HDC-2022-00074**Address: 1024 W. Chew Street****District: Old Allentown Historic District****Applicant: Jessica Cancel****Proposal: Install vent at Howard Street elevation; repoint brick****Building Description:**

Revised location of vent.
(Applicant; staff added line)

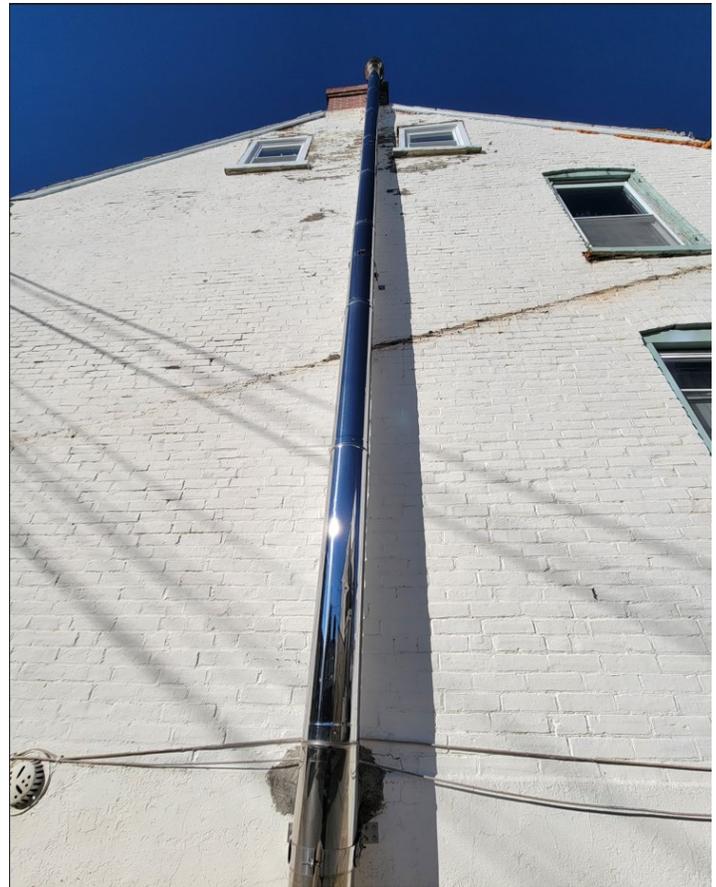
The proposed vent would be located on a highly visible contributing secondary façade and does not comply with the venting guidelines in Chapter 3.8 of the historic district guidelines, which recommend minimizing the visibility of vents and penetrations from the public right-of-way.

The applicant noted in the application that the existing chimney line was previously assessed and determined to be insufficient in size. With this condition, the proposed use of an exterior vent may be considered consistent with Guideline 3.8.9. An alternative vent design, similar to a direct vent (horizontal) type, would be less visually intrusive than a full height vent, provided that it complies with required codes. Painting the exterior vent to blend into the exterior brick wall would help the proposed work comply with Guideline 3.8.8.

Mr. Jordan asked whether the same chimney design and material as the HARB previously reviewed are still proposed, noting that the revision shows that the exterior vent would start between the first and second story. Property owner Jessica Cancel affirmed, adding that the vent would penetrate the wall higher than previously proposed to avoid obstructing the sidewalk. She argued that the existing chimney was improperly constructed in the past and cannot be safely used to vent the wood stove.

Mr. Jordan questioned whether the HARB made any previous recommendations. Ms. Keller stated that Easton Architects had provided information on a direct wall vent and that information was offered to the applicant. Mr. Jordan commented that the applicant seems willing to conceal the vent in some way, such as by painting to match the masonry, but that the design guidelines do not support the installation of the vent in the location proposed. Mr. McDermott responded that he would need to research whether the manufacturer provides guidance on painting the stack vent. Mr. Jordan questioned the process for providing a conditional approval based on whether the manufacturer recommends painting. Ms. Keller replied that the HARB could move to approve the exterior vent with the condition that staff review details so that she can confirm that the vent would be concealed to the greatest degree possible. She added that the HARB could consider offering a second option to approve the unpainted vent in the event that the manufacturer advises against painting.

The HARB discussed the design guidelines and concluded that the exterior vent in the location proposed does not comply with the guidelines. The HARB also noted that staff can approve the repointing work, assuming an appropriate mortar is used.

Approval of the masonry pointing, provided an appropriate mortar is used, pursuant to Chapter 3, Section 3.3 Masonry, and denial of the installation of the exterior vent, pursuant to Chapter 3, Section 3.8 Mechanical & Utility Equipment.

Mr. Huber moved to approve the masonry pointing, provided an appropriate mortar is used, with the staff to review details, pursuant to Chapter 3, Section 3.3 Masonry, and to deny the installation of the exterior vent at the Howard Street façade, pursuant to Chapter 3, Section 3.8 Mechanical & Utility Equipment. Mr. Hart seconded the motion, which carried by a vote of 3 to 1. Mr. Jordan dissented.
